**From:** Tavarez, Ike [Ike.Tavarez@tetrattech.com]  
**Sent:** Thursday, January 20, 2011 8:28 AM  
**To:** Bratcher, Mike, EMNRD  
**Subject:** RE: COG - Mesilla State #3 TB Work Plan Approval Request  
**Attachments:** COG - Mesilla State #3TB - Revised Work Plan .pdf

Report Type: Work Plan

*REVISED*

**Re: Work Plan for the COG Operating LLC., Mesilla State #3 , Unit H,  
Section 16, Township 17 South, Range 30 East, Eddy County,  
New Mexico.**

Figure 3  
Mesilla State #3  
Site Assessment Map  
Eddy County, New Mexico

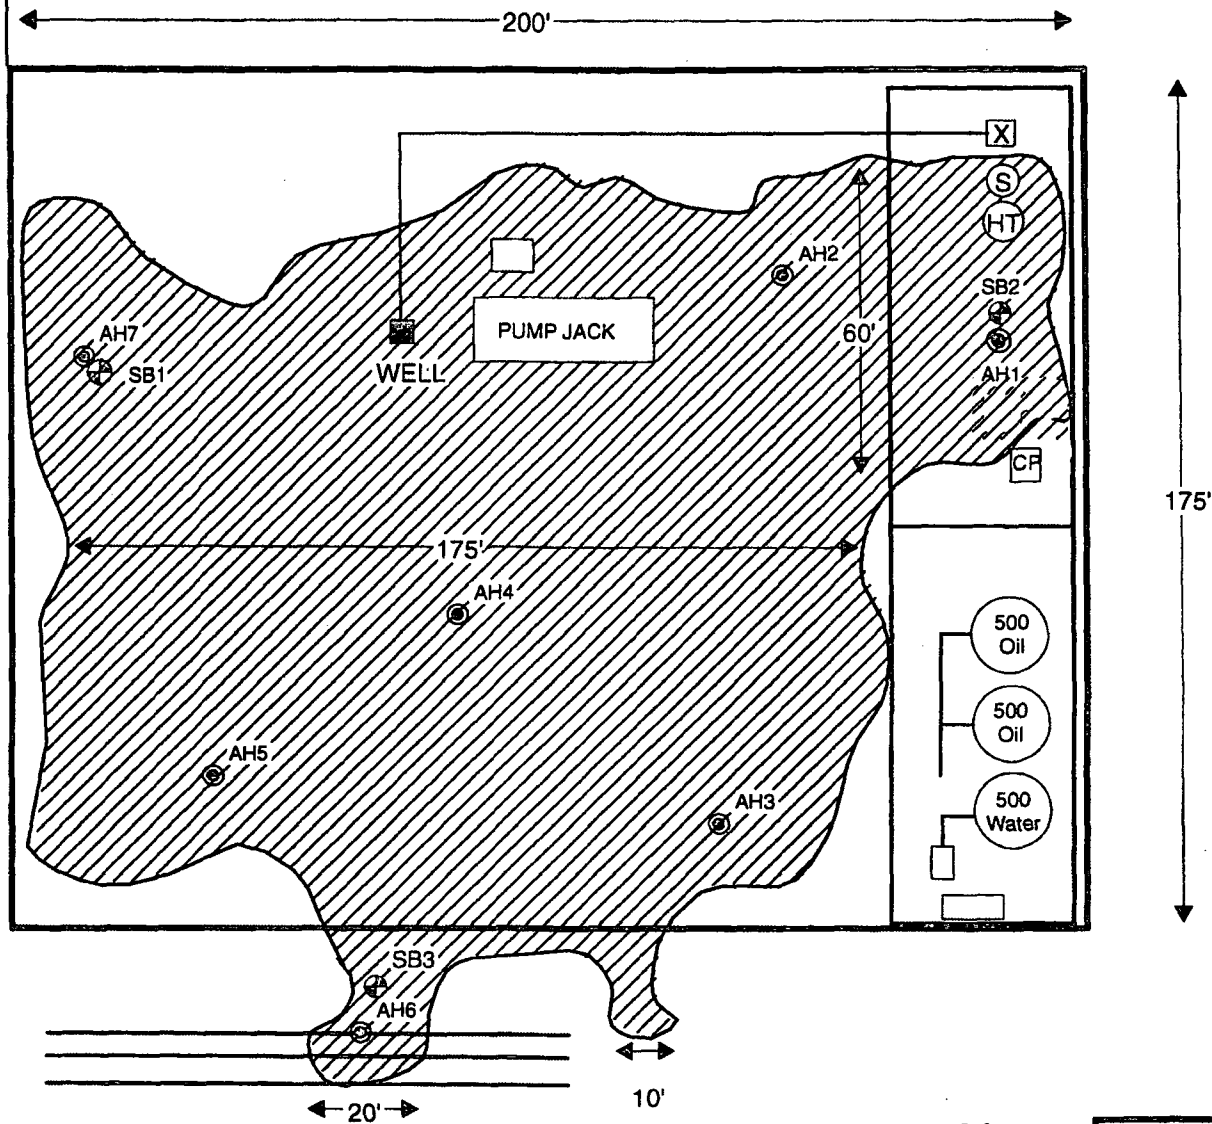
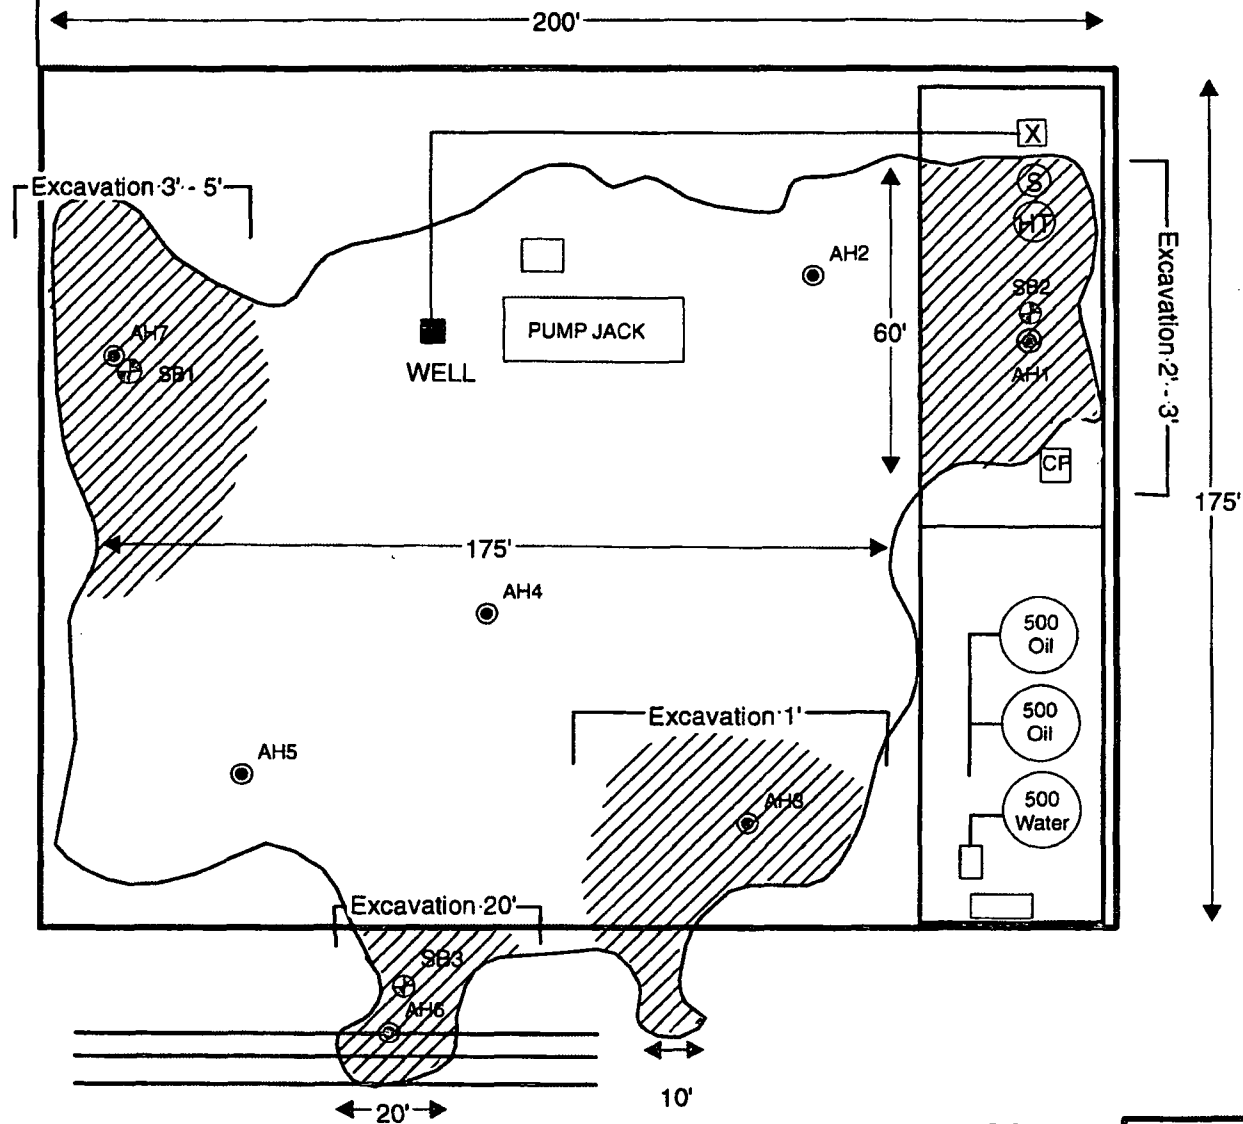
Will you review the labeling on the diagrams? I think SB-3/AH-1 and SB-2/AH-6 may be mislabeled.

I have revised the Figures for your review. Let me know if you need additional information, thanks.
